Access Compliance Report

Public Rights-of-Way

(Curb Ramps)

Intersection ID: 27440	Main Street: BALLANTYNE COMMONS PY	Cross Street: DOWINGTON DR	Location: SE
ADA ID: F1744BBBE742	Ramp Type: Perp	Initial Pass/Fail: Fail	Overall Compliance: No
Severity Score: 10			
Codes/Mitigation Info/Possible Solution		Field Measurements/Component Compliance

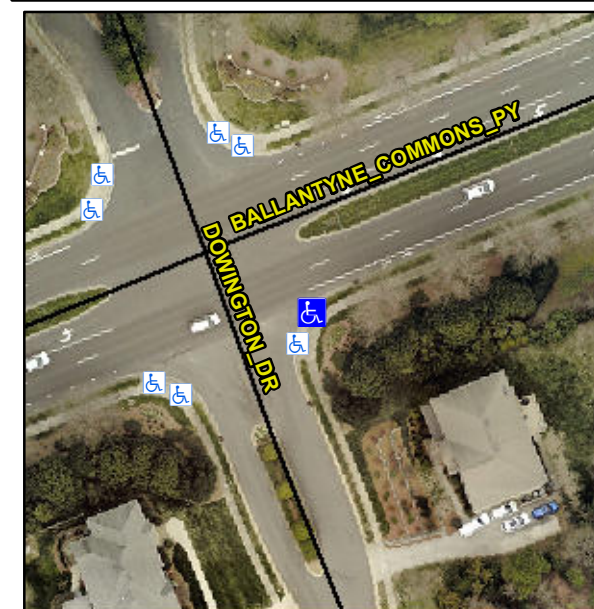
Not Found, R304.5.1, R304.5.3

Compliance	Description	Data	Compliance	Description	Data
N/A	Ramp Length (in)	108.0	Yes	Ramp Slope (%)	6.1
No	Ramp Width (in)	36.0	No	Ramp XSlope (%)	2.1
N/A	Flare Type LT	N/A	N/A	Flare Type RT	N/A
N/A	Flare Slope LT (%)	N/A	N/A	Flare Slope RT (%)	N/A
N/A	Flare Traversable LT?	N/A	N/A	Flare Traversable RT?	N/A
N/A	Landing Length (in)	N/A	N/A	DWS Provided?	N/A
N/A	Landing Width (in)	N/A	N/A	DWS Contrast?	N/A
N/A	Landing Slope (%)	N/A	N/A	DWS Length (in)	N/A
N/A	Landing X Slope (%)	N/A	N/A	DWS Full Width?	N/A
N/A	Landing Curb? (Y/N)	N/A	N/A	DWS Offset (in)	N/A
N/A	Shared Landing?	N/A			
N/A	Gutter Ponding?	N/A	N/A	Gutter Slope (%)	N/A
N/A	Gutter Lip Ht (in)	N/A	N/A	Gutter X Slope (%)	N/A
N/A	Painted X Walk1?	No	N/A	Painted X Walk2?	N/A
	X Walk 1 Direction	To N		X Walk 2 Direction	N/A
N/A	X Walk 1 Width (in)	N/A	N/A	X Walk 2 Width (in)	N/A
	X Walk 1 Slope (%)	2.7		X Walk 2 Slope (%)	N/A
	X Walk 1 X Slope (%)	1.6		X Walk 2 X Slope (%)	N/A

Possible Solutions:

Remove & Replace Entire Ramp.
